GENERAL INFORMATION

Applicant:	SICK Product & Competence Center Americas, LLC (applicant) City of Bloomington (owner)
Location:	8050 Winstead Way, 2701 American Blvd. E., 8000 and 8051 26 th Avenue S.
Request:	Final Development Plans for Phase 2 of the SICK technology campus, an approximately 144,000 square foot office building and a parking structure, located at 8051 Winstead Way and 8051 26th Avenue E.
Existing Land Use and Zoning:	Technology campus and vacant land; LX(PD)(AR-17) Lindau Mixed Use (Planned Development)(Airport Runway AR-17)
Surrounding Land Use and Zoning:	North – Vacant; zoned C-4(AR-17) South – Office and financial institution; zoned LX(AR-17) East – Hotel and transit parking; zoned LX(PD)(AR-17); West – Hotels; zoned LX(AR-17) and LX(PD)(AR-17)
Comprehensive Plan Designation:	Lindau Mixed Use

SICK Product & Competence Center Americas, LLC (SICK) is seeking approval for Phase II of their technology campus. The SICK technology campus is a four-phase development consisting of office, warehouse, research and development, and production spaces. Phase I was approved in 2021 and is complete. Phase II would be an approximately 144,000 square foot, four-story office b

Graphic 3: SICK Phase II Rendering – East Building Elevation*

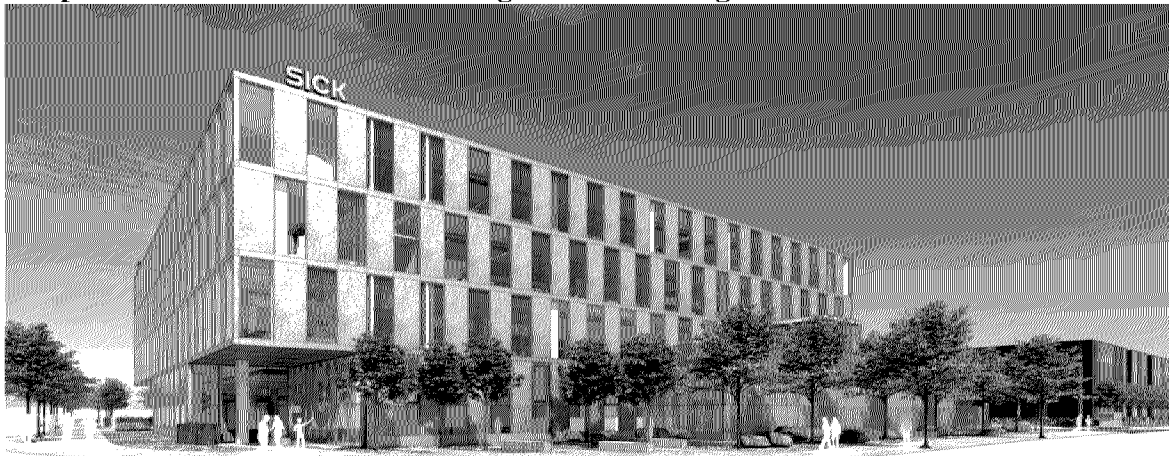
*This rendering depicts a roof sign. City Code prohibits roof signs.

The City's LX zoning district is a "mixed use district," which entails additional design standards. Building transparency between two and ten feet above grade is one of those standards. Essentially, the City Code requires significant first floor transparency to add street-level visual interest and activity. A primary street, in this case Lindau Lane, must have at least 50 percent first floor transparency. The proposed first level exceeds the City Code requirement with 70 percent transparency between two and 10 feet. However, the elevation depicts a large building sign on the south elevation. A sign installed outside of the transparent materials would negate that area being considered transparent. An alternative discussed with the applicant would be to install text inside the building on an internal wall. This option would not be considered a sign and would not block transparent exterior material along Lindau Lane. Additionally, the total on-building signage area exceeds City Code allowances.

A secondary street, Winstead Way, is required to have at least 25 percent transparency. The secondary building elevation is slightly above the Code requirement with 26 percent transparent material. While only slightly above the Code requirement, the building would contribute to a positive pedestrian scale environment for several reasons:
